**STAFF REPORT
 PLANNING DIRECTOR DECISION**

DATE: July 15, 2013
 FILE NO.: MIP-13-02
 REQUEST: Request for a 3-lot Partition at 1700 Santa Anita Drive
 PLANNER: Tom Soppe, Associate Planner

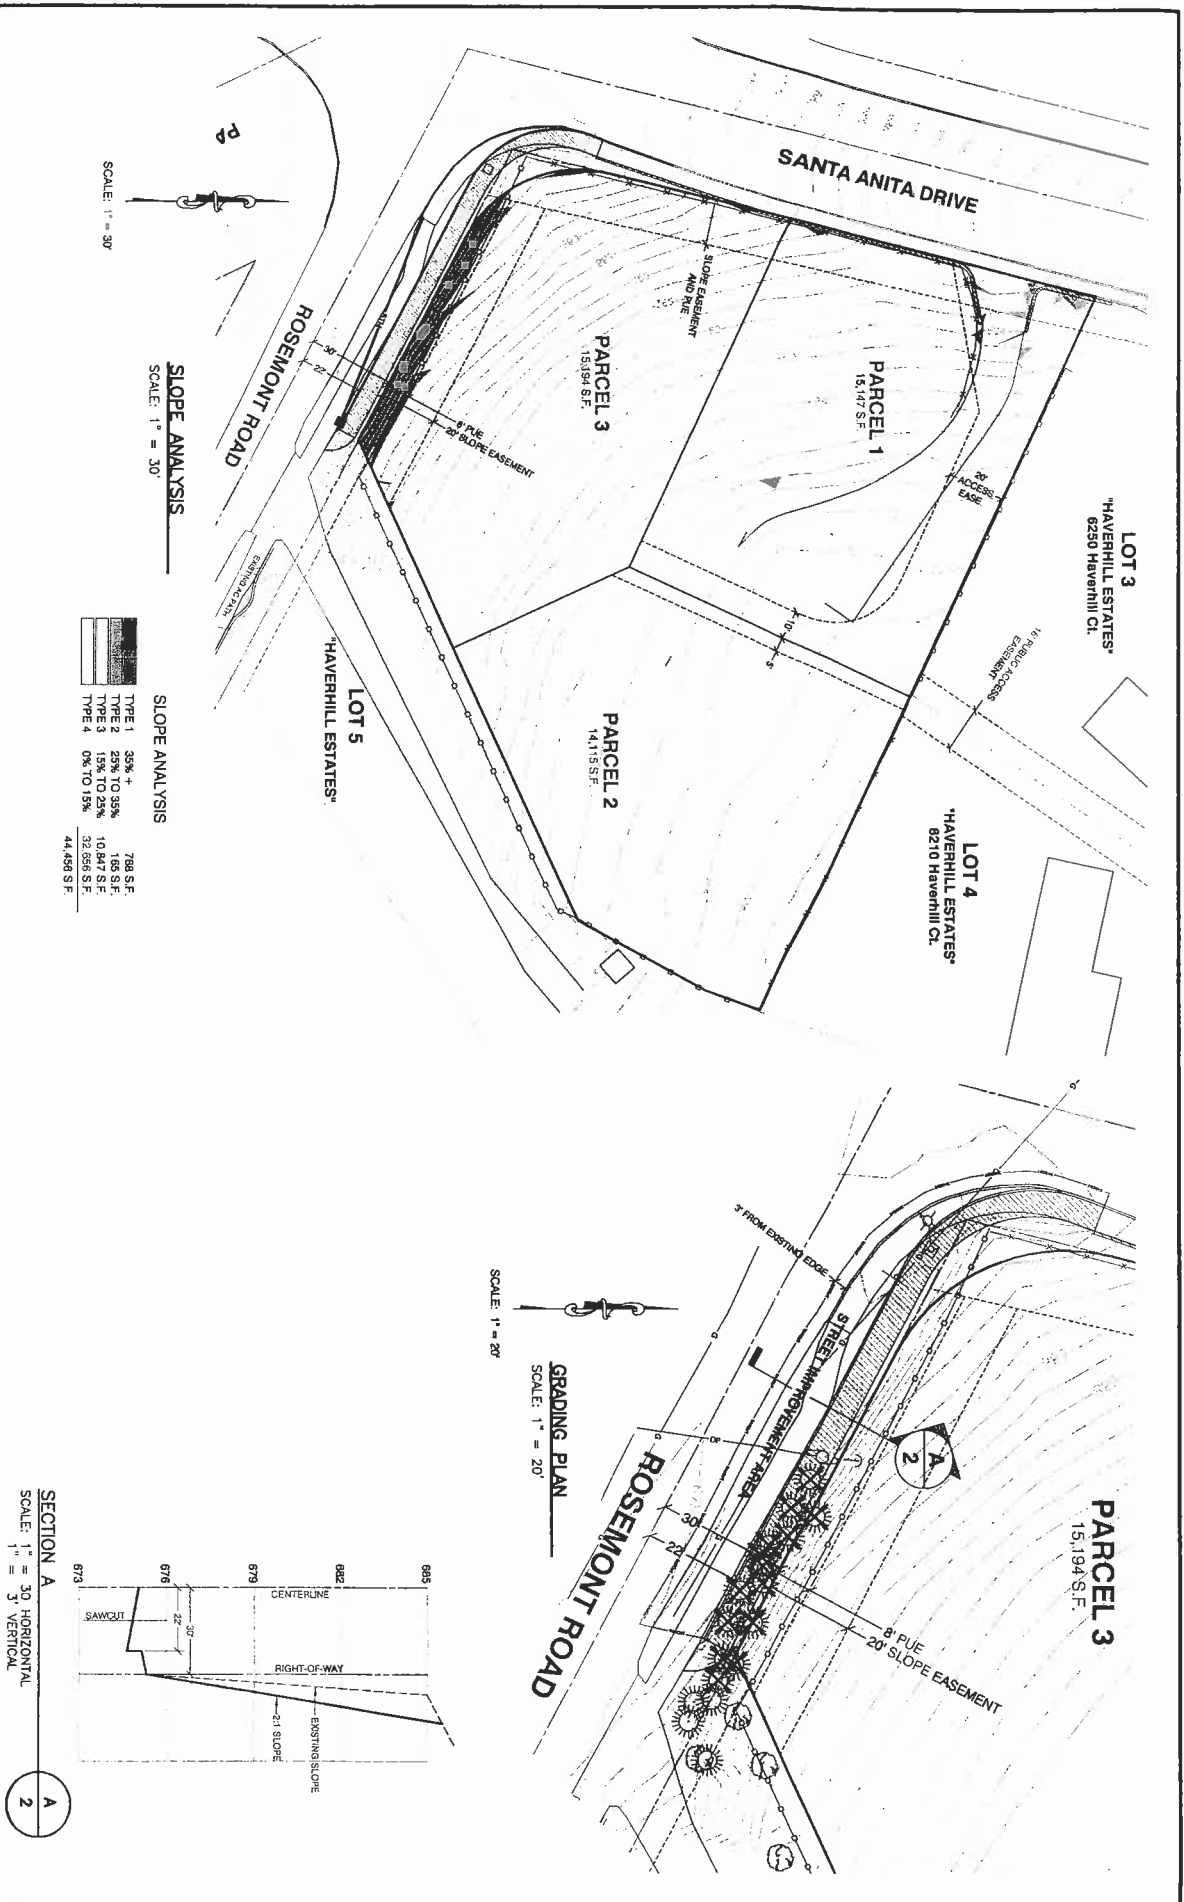
The applicant's Tentative Plan Sheet 1/3 on Page 71 of Exhibit PD-4 proposes street trees on Rosemont Road but not Santa Anita Drive. To fulfill the street trees requirements of 85.200(J)(3) Street Trees, Condition of Approval 8 is recommended as it requires street trees on both street frontages.

Staff Response 40: No trails are proposed. While there is a public access easement between adjacent lots 3 and 4 in the Haverhill Estates subdivision (see Three Lot Partition Tentative Plan, Sheet 1/3, on Page 71 of Exhibit PD-4), these two lots are already developed with houses and there is already a public walkway in an easement just on the other side of Haverhill Estates Lot 3, connecting Santa Anita with Haverhill Way. Therefore the proposed partition does not need to make this connection with a trail. Staff determines the criterion is met.

Staff Response 46: Street trees are required on both streets. The applicant shows street trees proposed along Rosemont Road on the Tentative Plan Sheet 1/3, Page 71 of Exhibit PD-4. There should be street trees planted along the Santa Anita frontage also per Chapter 54 requirements. In both cases, sidewalk location and topography make it so trees have to be opposite the sidewalk from the street, which is acceptable when dictated by circumstances such as this. Condition of Approval 8 requires street trees be planted along both frontages. Staff finds that the criterion is met upon the inclusion of Condition of Approval 8.

1. Site Plans. The improvements shall conform to the Three Lot Partition Tentative Plan (Sheet 1/3) on Page 71 of Exhibit PD-4, dated April, 2013 (stamped received June 17, 2013), except as modified by these conditions of approval.

8. Street Trees. The applicant shall plant street trees along both street frontages consistent with West Linn Municipal Code subsection 8.720, Street Trees, and the Tree Technical Manual, as approved by the City Arborist.
